City of Ontario

ADDENDUM NO. 3

D&C23-015 Anthony Munoz Gymnasium

Today's Date is Friday, September 11, 2026

SHEET:
A0.1

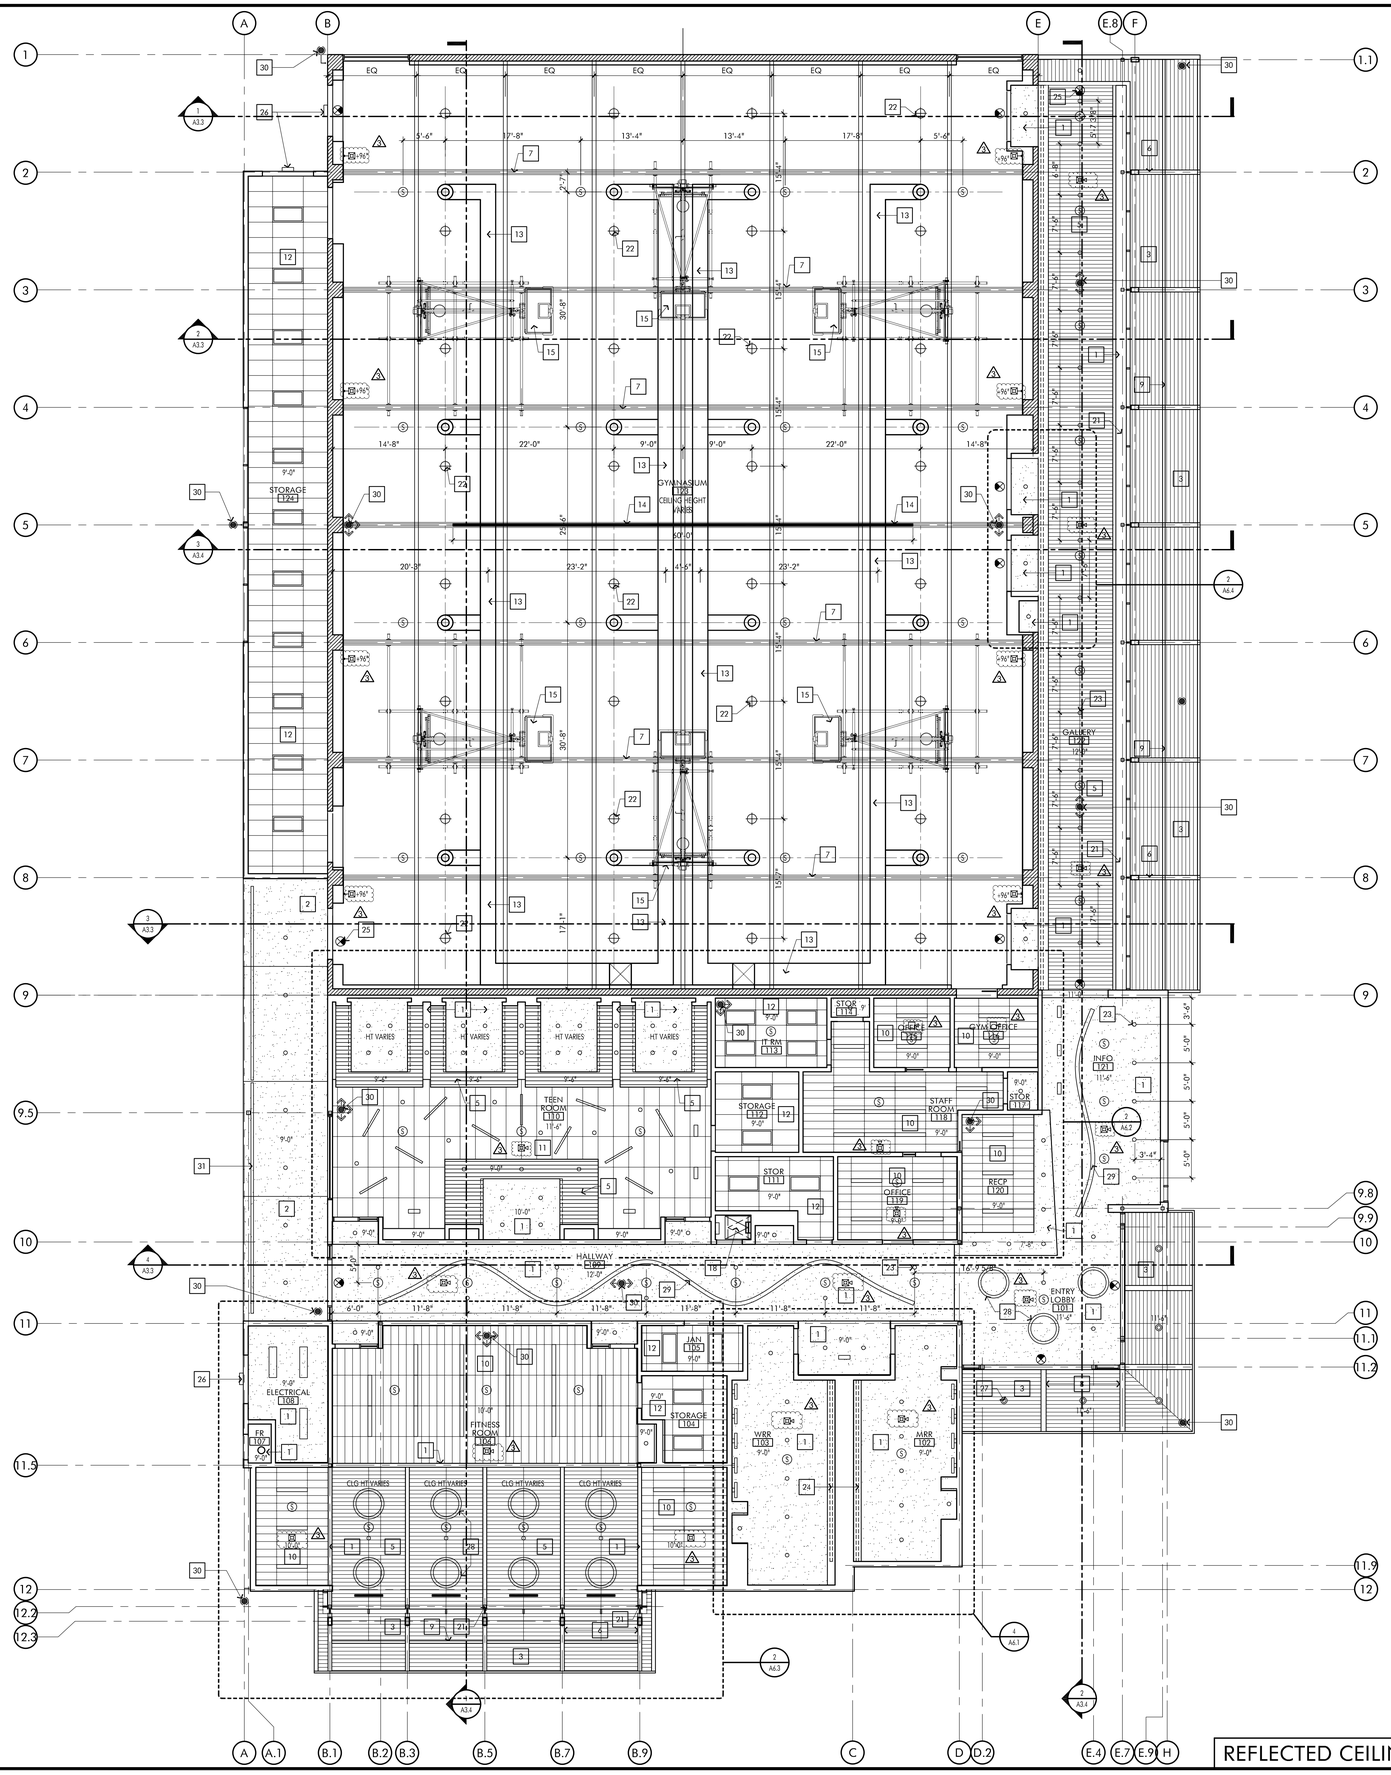
1. A0.1 Title Sheet
    a. Removed "For Reference Only" preceeding the Landscape Drawings in the Sheet Index. The Landscape Drawings are part of the Bid Documents.

SHEET:
A5.3

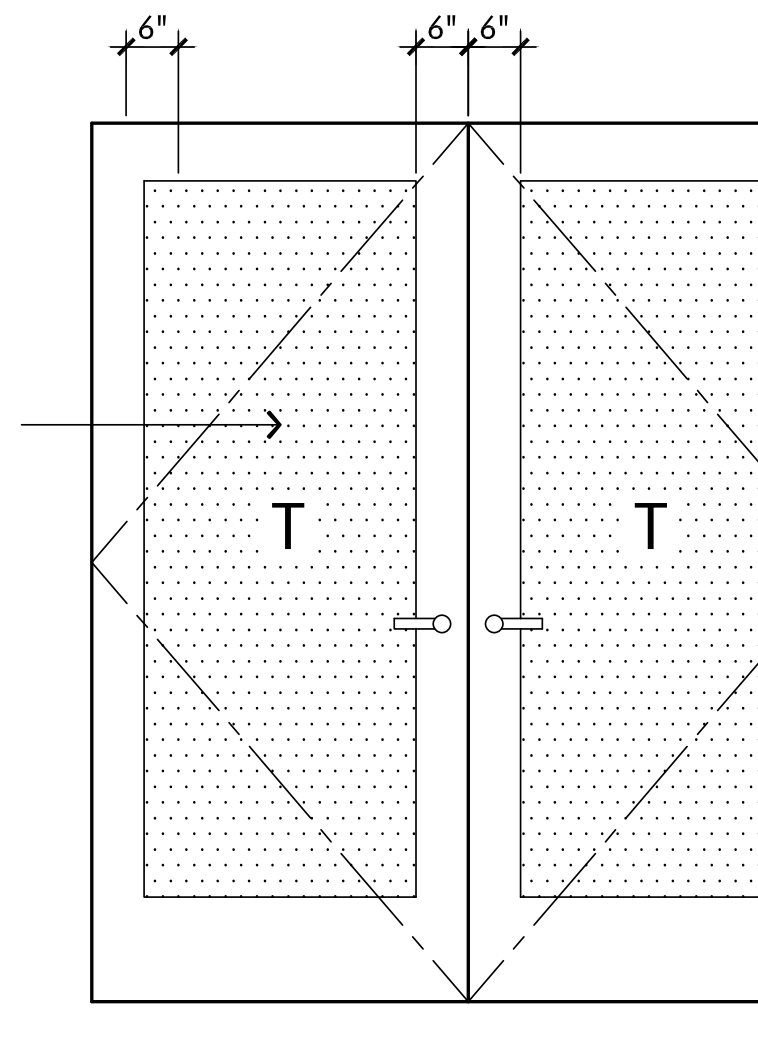
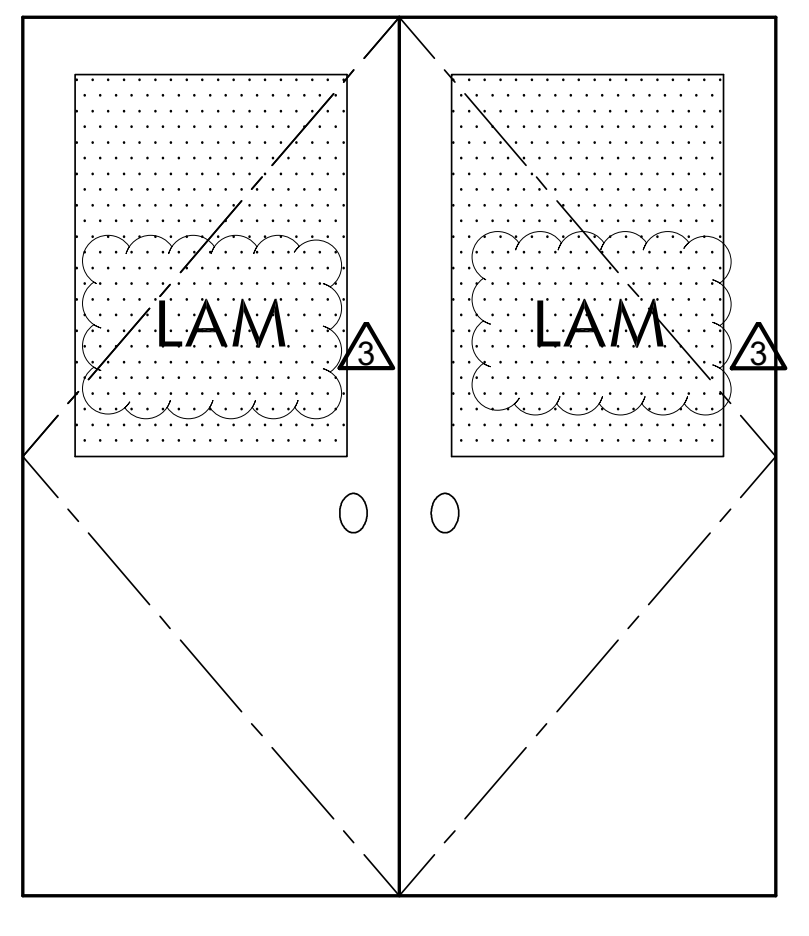
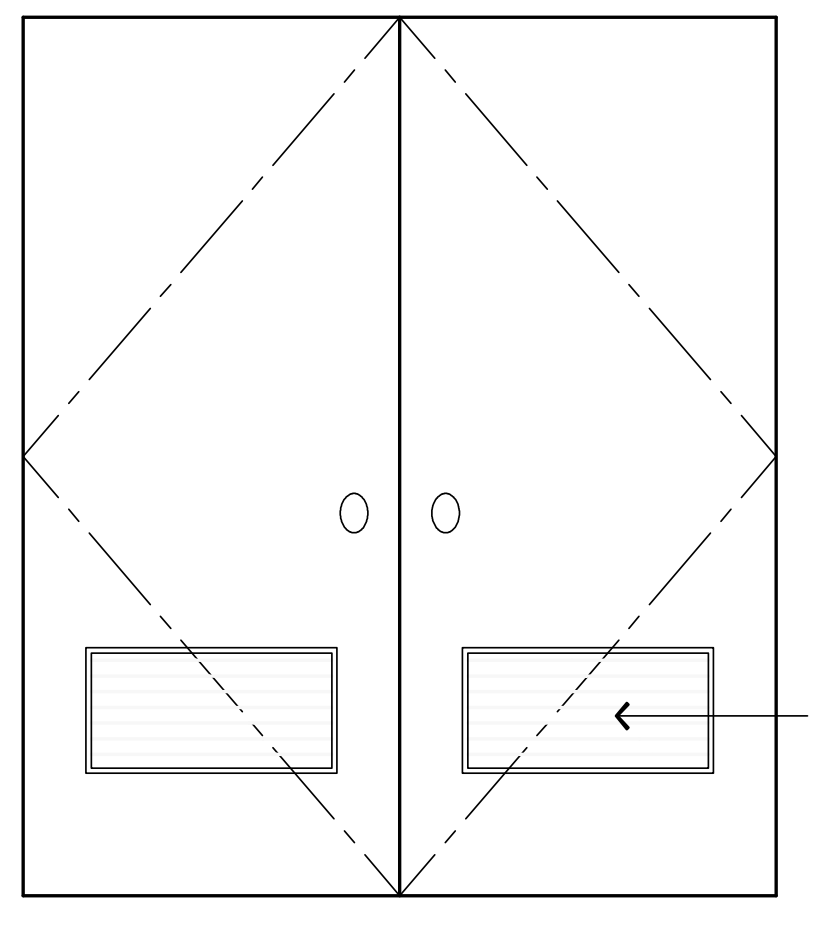
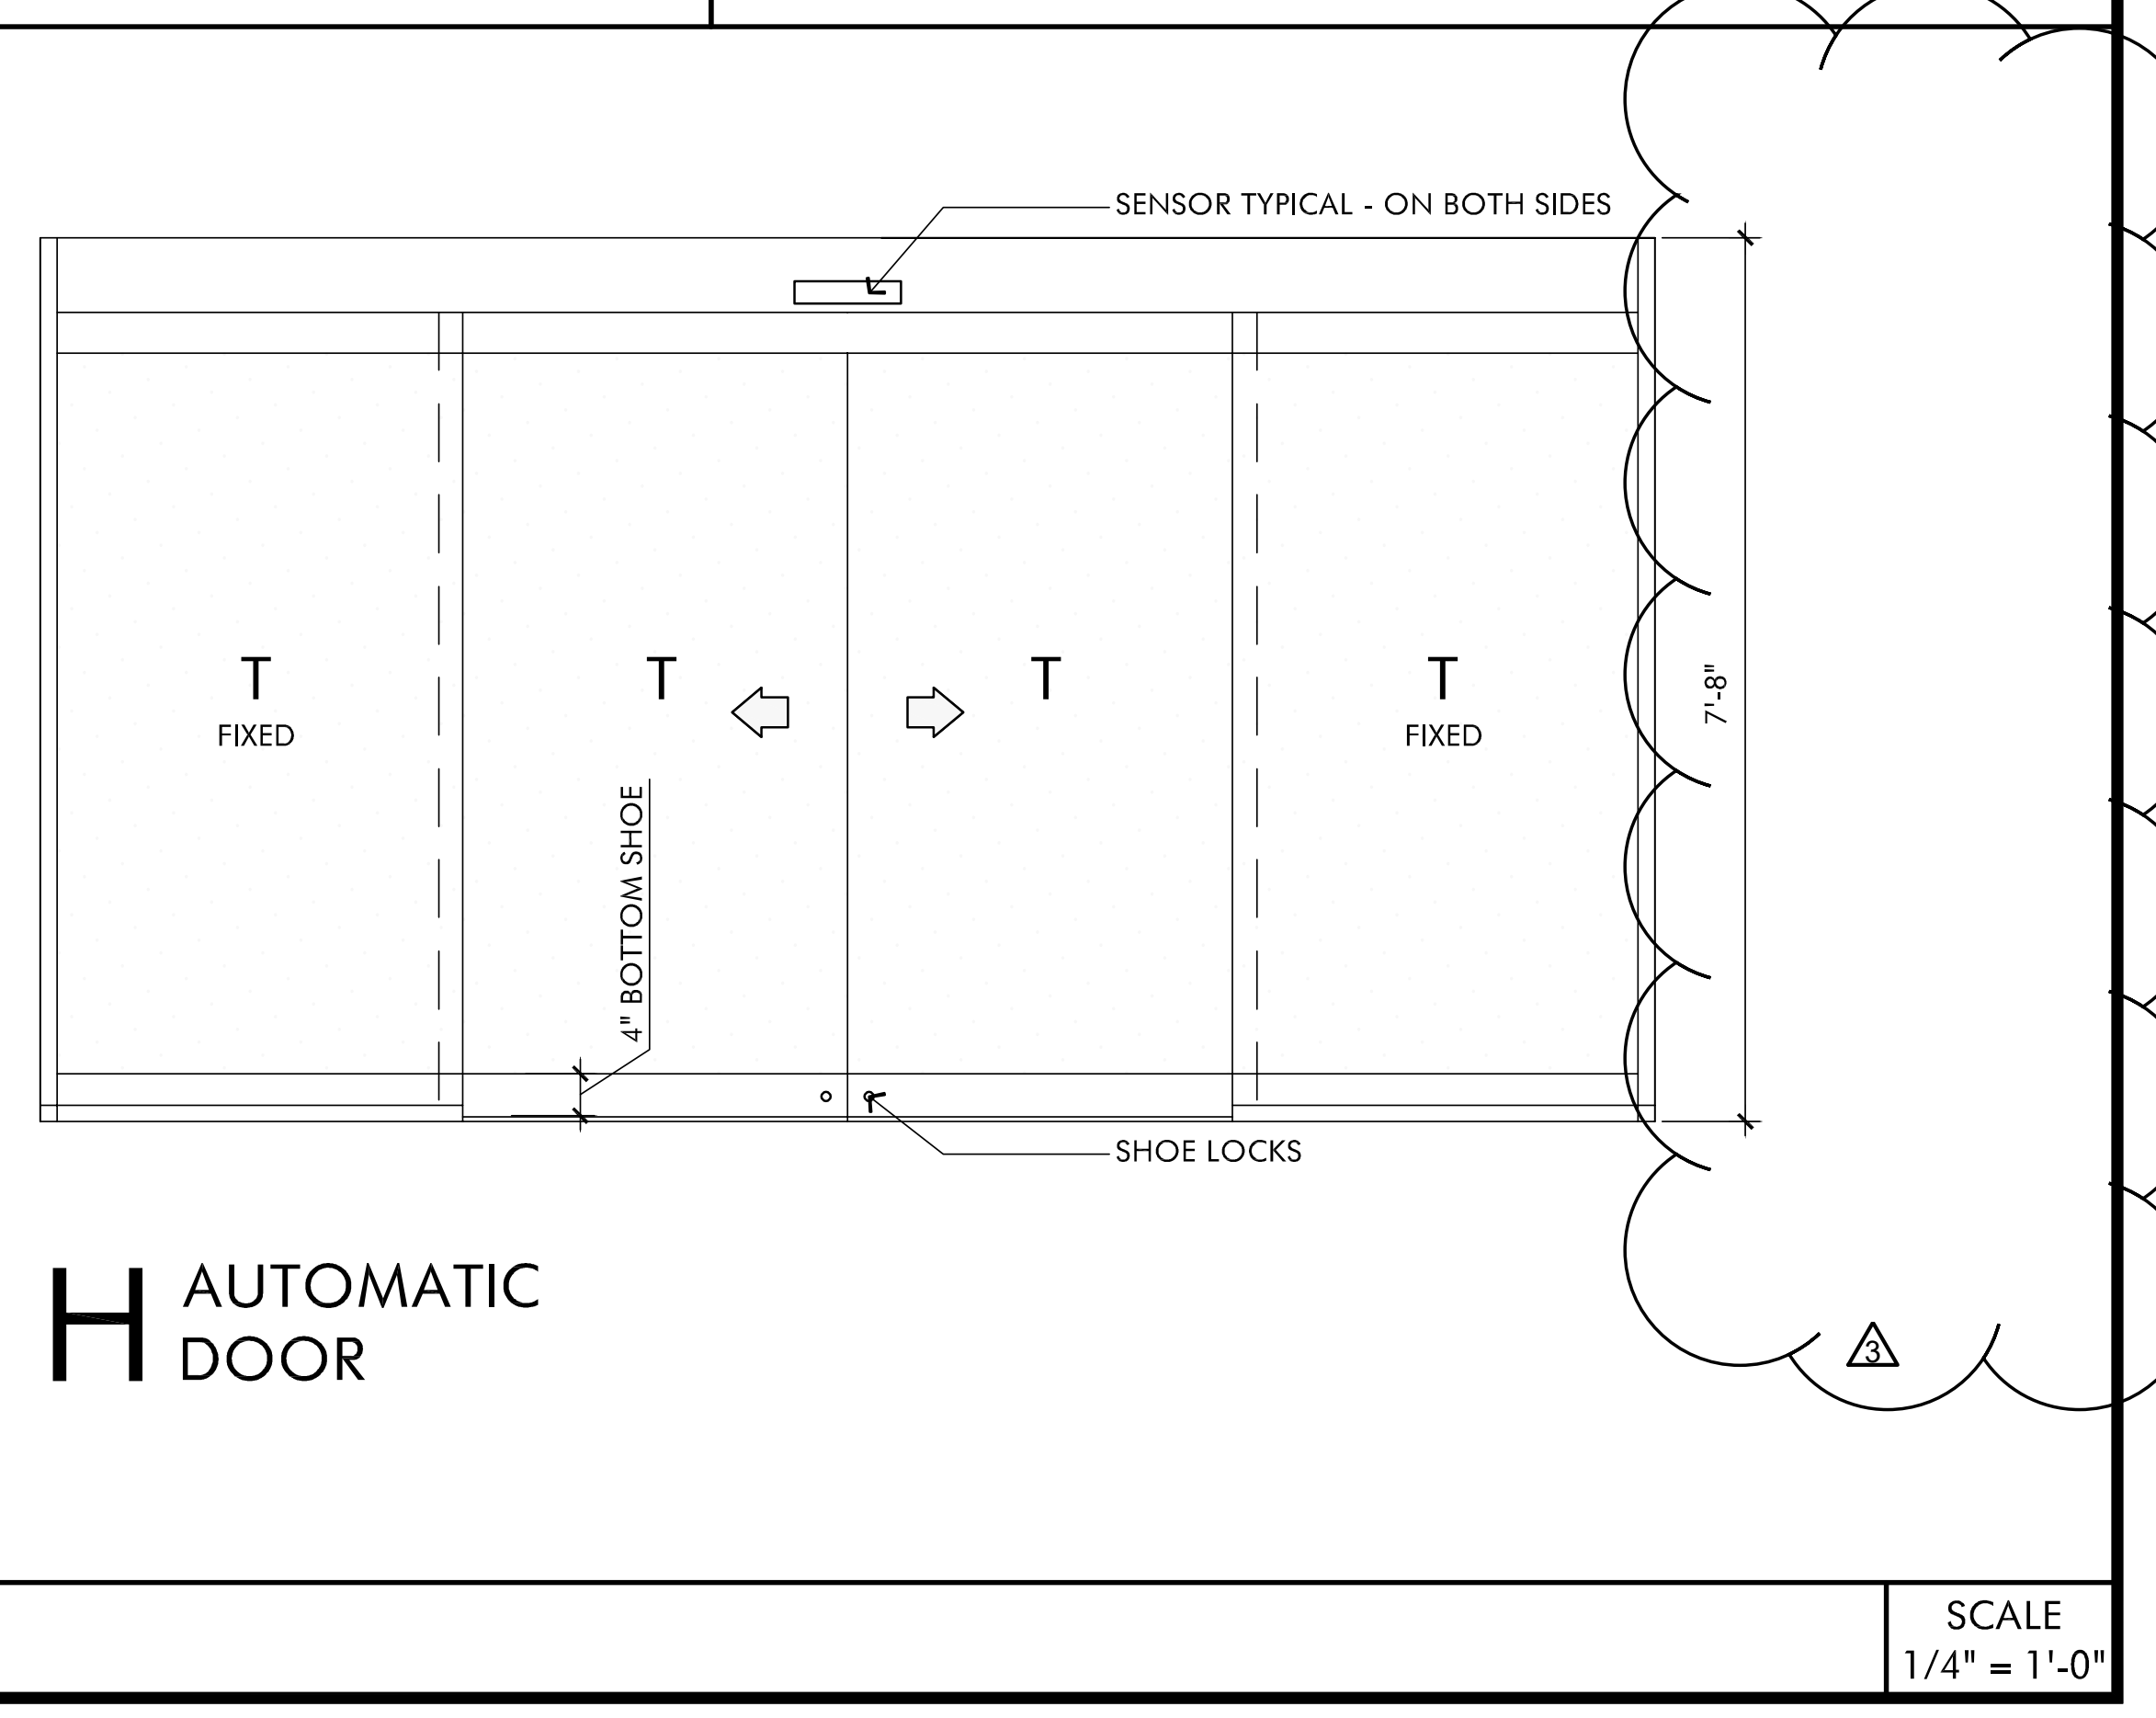
2. A2.3 Reflected Ceiling Plan
    a. Added Fire Alarm devices to the ceiling plan to coordinate with Sheet E2.2.
3. A5.3 Door Schedule & Types
    a. Removed Door Type I from door type details.

b. Revised Door 121 on schedule.
    c. Revised glass type on Doors 123, 124, 125 & 126.
    d. Revised glass type on Door Type Legend.
4. A5.4 Window Schedule & Types

SHEET:
A5.4

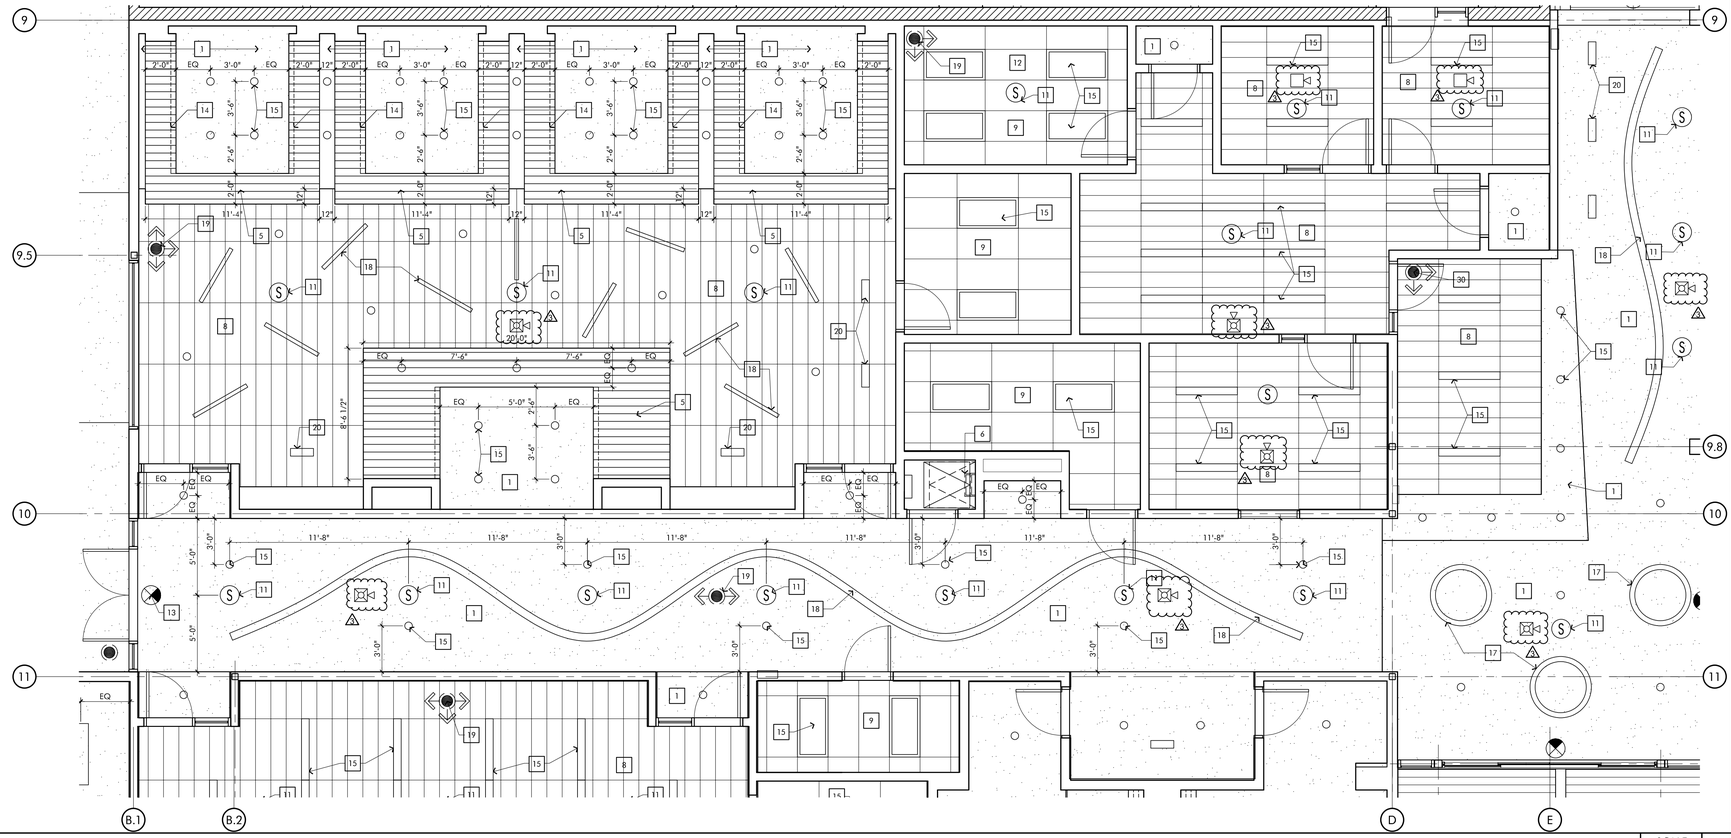
a. Revised window opening 32.
5. A6.2 Enlarged Floor Plan
    a. Added ceiling devices to detail #2.
6. A6.3 Enlarged Floor Plan
    a. Added ceiling devices to Detail #2.

WINDOW JAMB DETAIL | SCALE 3" = 1'-0" | 12

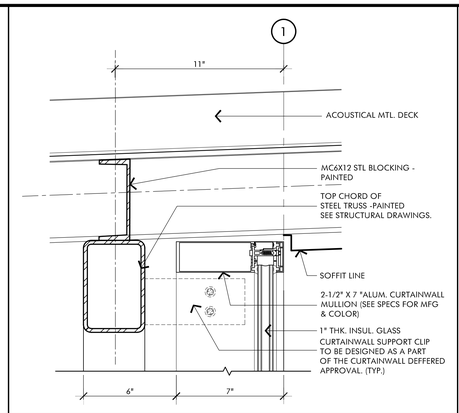
7. A7.1 Interior Elevations
    a. Revised door opening on Detail #2 to match floor plan.
8. A8.4 Misc. Window / Mullion Details
    a. Revised Detail #12.

SHEET: E0.4

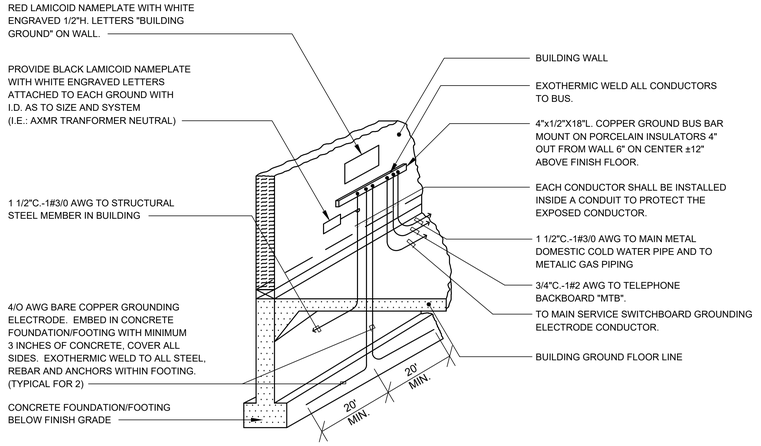
1. E0.1 Symbol List and General Notes
    a. Added symbols for the Fire Alarm Control Panel and Fire Alarm Enunciator Panel
2. E0.4 Single Line Notes and Details
    a. Added Notes 2 and 3 to Keynotes.
    b. Added new Circuit Breaker and modifications to Main Switchboard in Single Line Diagram 1.
3. E0.6 Enlarged Electrical Room and Details
    a. In Main Electrical Room Plan Detail 1 added location for Fire Alarm Control Panel
    b. Omitted Detail 9 for Light Bollard Fixture Type S2.
4. E0.7 Panel Schedule
    a. Panel GFB – Revised the panel size from 225 A to 400 A.
    b. Panel GBC – Added emergency battery inverter to panel.
5. E1.1 Site Plan
